# Local Planning Panel 10 August 2022

Address: 25-27 Dunning Avenue, Rosebery

D/2021/1491

Alterations and additions to heritage warehouse building to create a five storey commercial development

## **FSR**

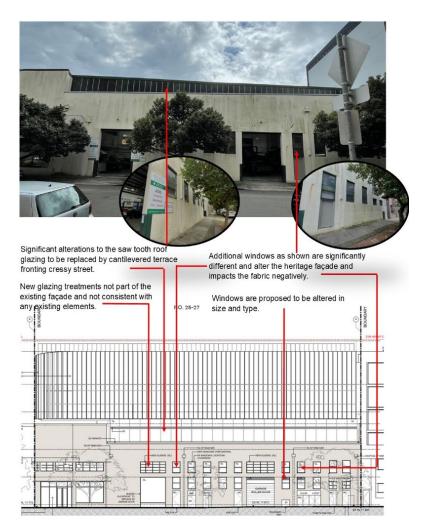
- Proposed FSR 3.1:1 (2,966sqm)
- Control Max 2.3:1 base FSR 1.5:1, community infrastructure bonus 0.5:1, end of trip facilities up to 0.3:1
- The proposed bonus FSR of 0.5:1 is not supported as does not meet objectives of controls
- The proposed end of journey FSR is 0.076:1 (73sqm) which is accepted
- The 4.6 variation is based on the base FSR and is requesting 107% variation to the standard.

## Impacts on adjacent development

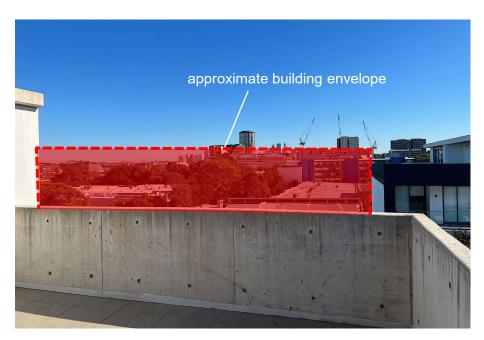
- View loss issues were raised in submissions
- A proposal with reduced FSR would facilitate reduced impacts
